## **TEMPORARY DRAINAGE PROPOSAL**

APPLICATION SITE OF PROPOSED TEMPORARY PUBLIC VEHICLE PARK FOR MEDIUM GOODS VEHICLES FOR A PERIOD OF 3 YEARS AT LOTS 1621, 1623 (PART), 2700, 2703, 2704 (PART), 2705 (PART), 2706, 2707, 2708 (PART), 2709 (PART), 2710 (PART), 2711 (PART) AND 2713 (PART) IN D.D. 129, LAU FAU SHAN, YUEN LONG, NEW TERRITORIES.

**PROJECT NO. TDM/011\_TOP**

**Response to Comments on Temporary Drainage Proposal (Issue 1)**

Appendix C - Proposed Drainage Plan

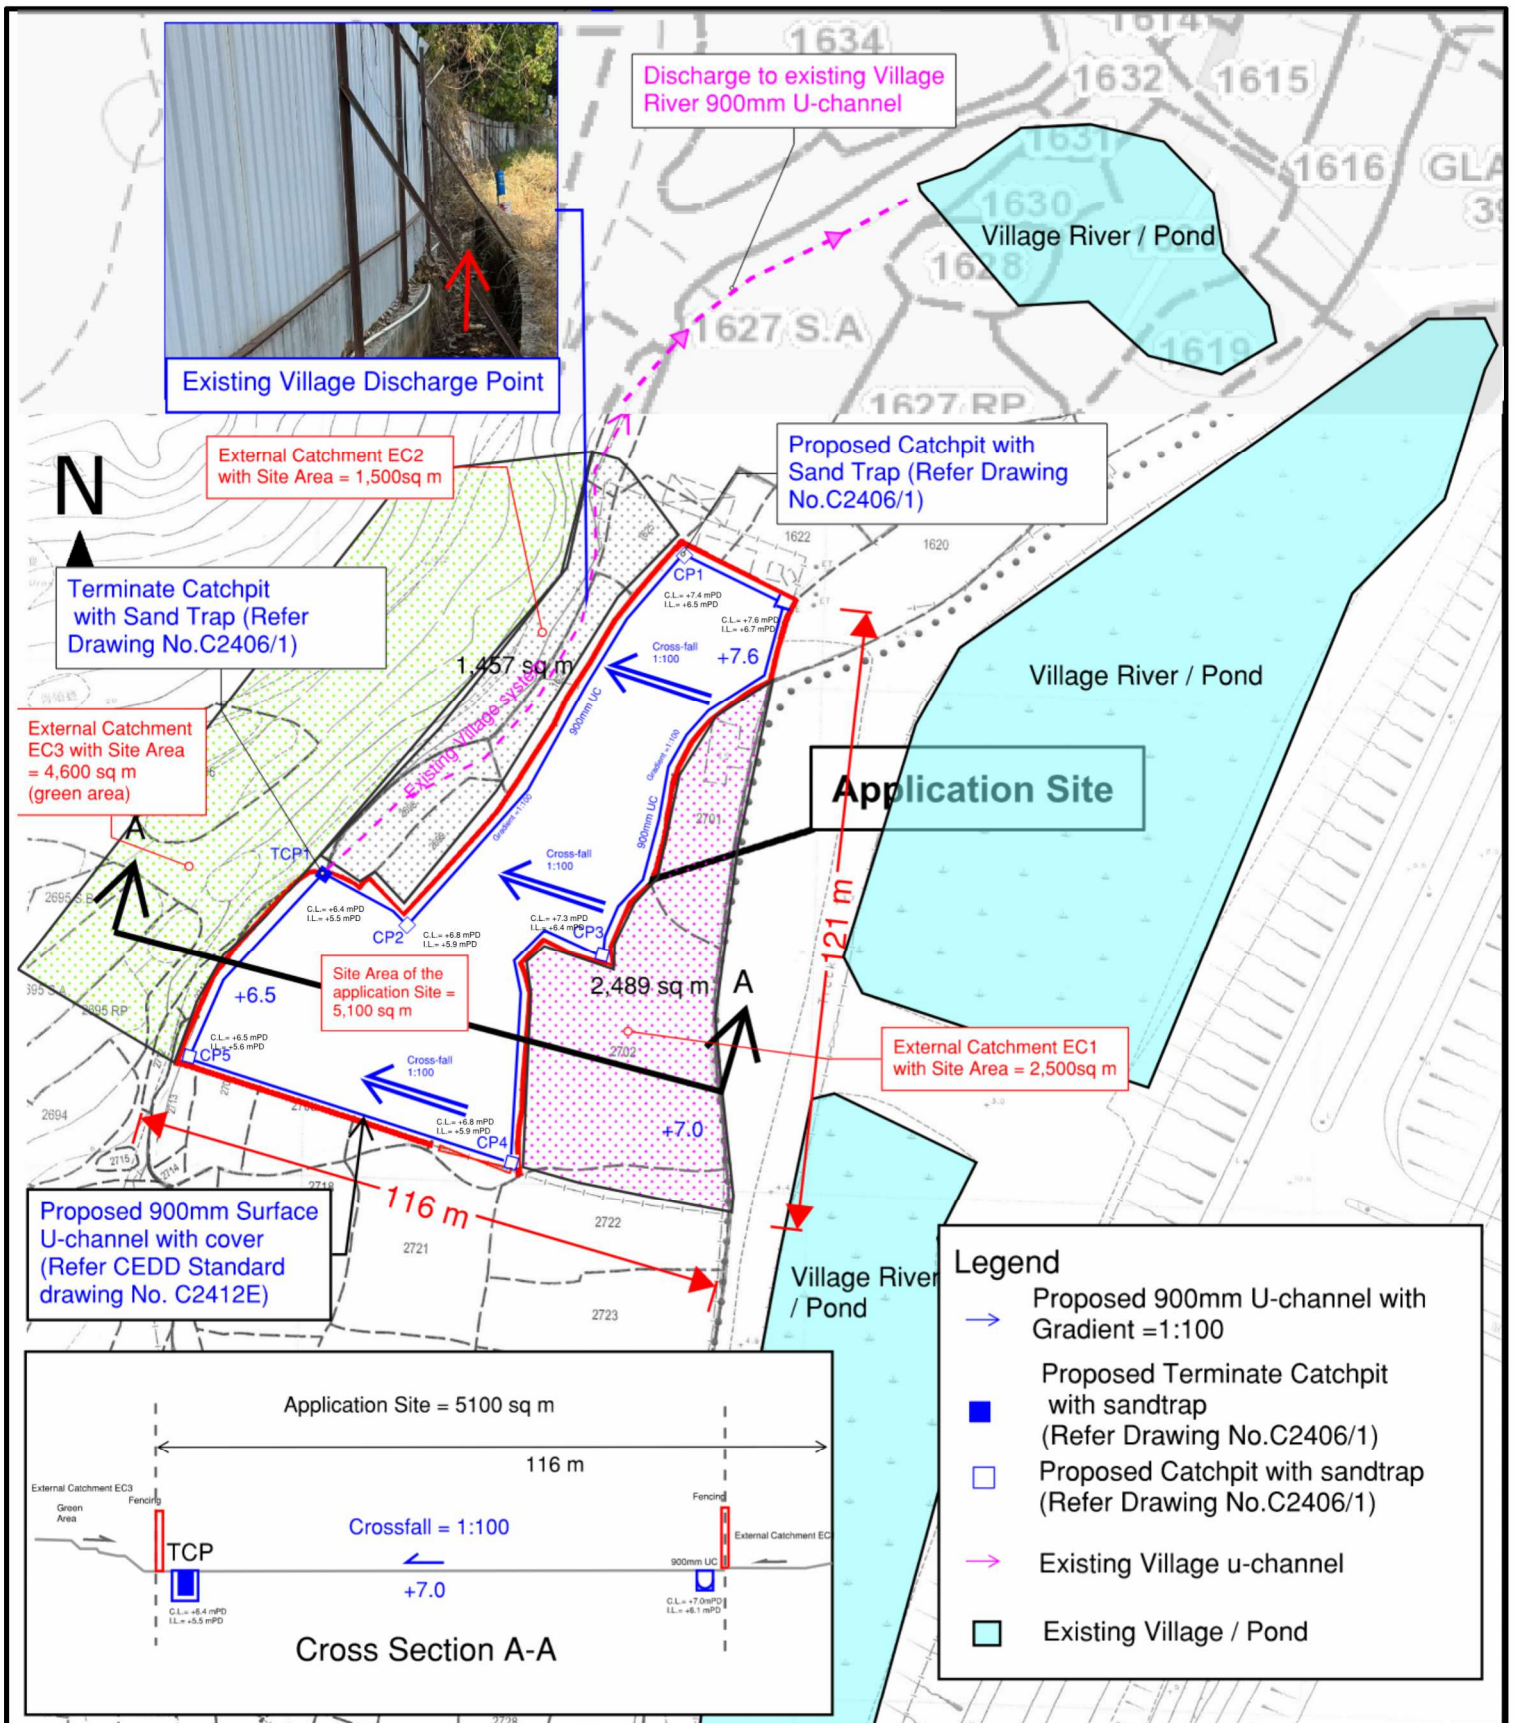
No.	Comments	Response
1.	Peripheral surface channels shall be provided along the site boundary to collect the surface runoff accrued on the application site and to intercept the overland flow from the adjacent land.	Noted. Please refer to the revised Appendix C – Drainage Plan.

3.	Further to item (ii) above, since there is no record of the said discharge path, please provide site photos to demonstrate its presence and existing condition.	Noted. Please refer to the Appendix C - Drainage Plan.

5.	Sand trap or provision alike should be provided at the immediate discharge point outside the application site boundary before the before conveying to any drainage system fall outside the application site.	Terminate Catchpit with Sand Trap is provided at the discharge point of the application site. Noted. Please refer to the revised Appendix C – Drainage Plan.

6.	Cross sections showing the existing and proposed ground levels of the captioned site with respect to the adjacent areas should be given.	Noted and provided. Please refer to the revised Appendix C – Drainage Plan.

**CATCHPIT WITH TRAP  
(SHEET 2 OF 2)**

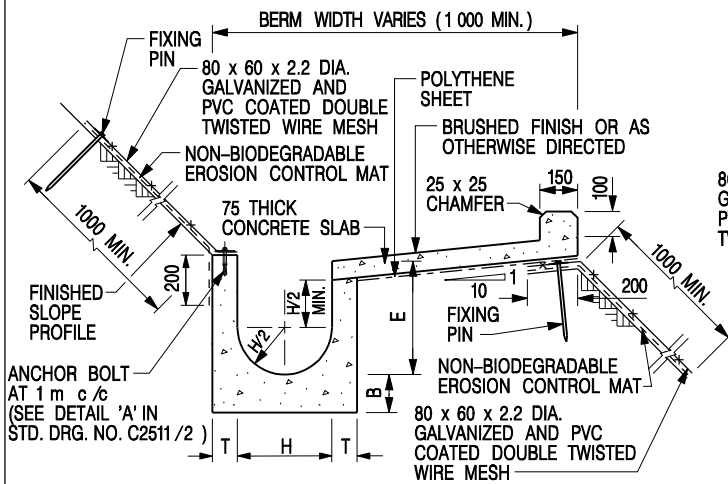
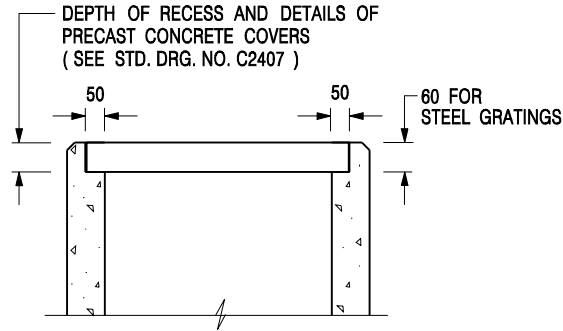
<b>No.</b>	<b>Comments</b>	<b>Response</b>
1.	The cover levels and inverted levels of the proposed u -channels, catchpits/sand traps should be shown on the drainage plan.	Noted and provided. Please refer to the revised Appendix C – Drainage layout.
2.	Standard details should be provide to indicate the sectional details of the proposed u-channel and the catchpits/sand traps.	The standard details are provide in Appendix E - Typical Standard Drawings of U-Channel and Catchpit.
